Subject ▶ Changes on side handle and carrying case

For Models ▶ HR5000,HR5000K(50mm Rotary Hammers)

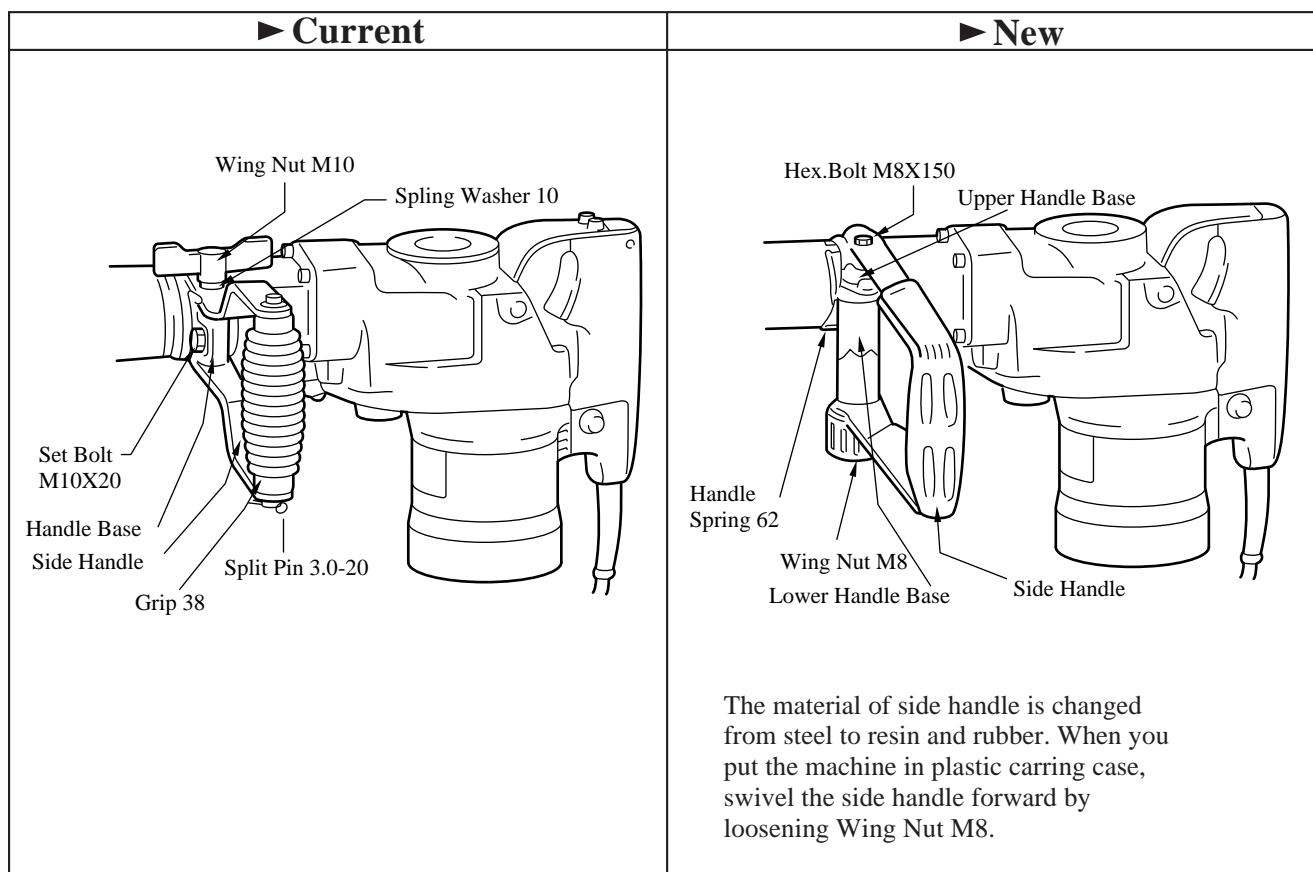
Description ▶ As in illustrated below, side handle has been changed for lower cost.

Item No.	Current part		Q'ty	I/C	New part		Q'ty	
88	Side Handle 343519-9		1	No	Side Handle 416061-4		1	<div> <div>↑</div> <div>The current remains available for replacement.</div> <div>↓</div> <div>Interchangeable as a set</div> <div>↑</div> </div>
	Grip 38 273492-8		1					
	Split Pin 3.0-20 952257-8		2					
89	Wing Nut M10 259020-3		1	No	Wing Nut M8 252640-2		1	
91	Set Bolt M10X20 265902-9		1	No	Hex Bolt M8X150 265439-6		1	
120	Handle Base 414774-1		1	No	Upper Handle Base 416060-6		1	
121					Lower Handle Base 416089-2		1	
	Spring Washer 10 942251-8		1					
400	Steel Carrying Case 182703-9		1	No	Plastic Carrying Case Complete 150589-9		1	HR5000 U.K.,France,Germany, Netherlands,Spain, Italy,Reunion,Algeria, Austria,Sweden, Norway,Finland, Switzerland,U.S.A.,Guam and Canada
400	Steel Carrying Case 182701-3		1	No	Plastic Carrying Case Complete 150582-3		1	HR5000K

Correction of I/C(Interchangeability) in TEC-126/95(R) and TEC-127/95(R):

I/C was "Yes" in the Technical Informations.

However, it is now "No" as the side handle has been changed as described above.
